DATE: 19-Sep-16  
TO: Auto Crane Dealers  
SUBJECT: NexStar III – Remote Trigger Repair

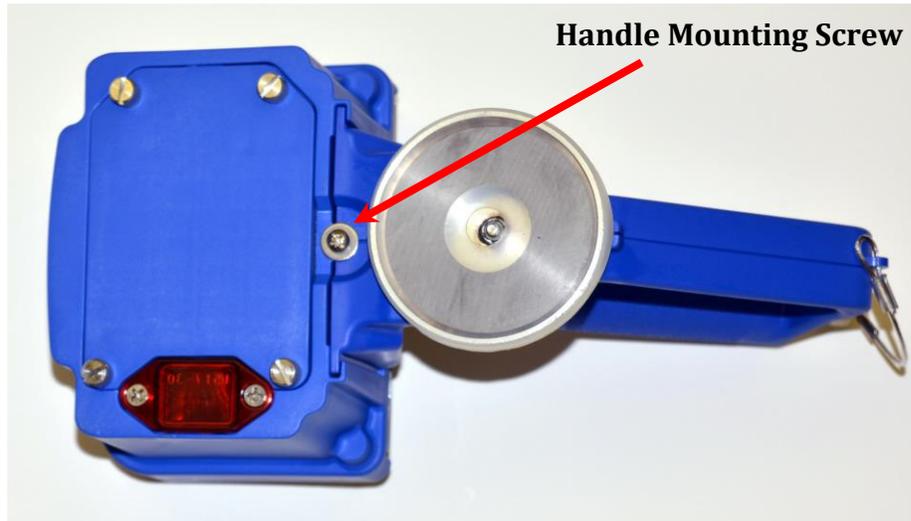
NexStar III remotes manufactured prior to April 2016 have the potential issue where the trigger magnet separates from the plastic trigger. Remotes with RA number less than 125237 may experience this issue. Crane operation will not be possible when the magnet detaches from the trigger.

The magnet-to-plastic trigger adhesion quality was improved as part of the corrective action on remotes with 678366-48257-TX1 or RA 125237 or greater.

The handle is replaced by removing the cross-head screw shown below then carefully sliding the handle up from the upper remote housing and then unplugging the connector. Reverse these steps to install the new handle.

Remotes which experience this failure can be repaired by replacing the handle (P/N 366823967).
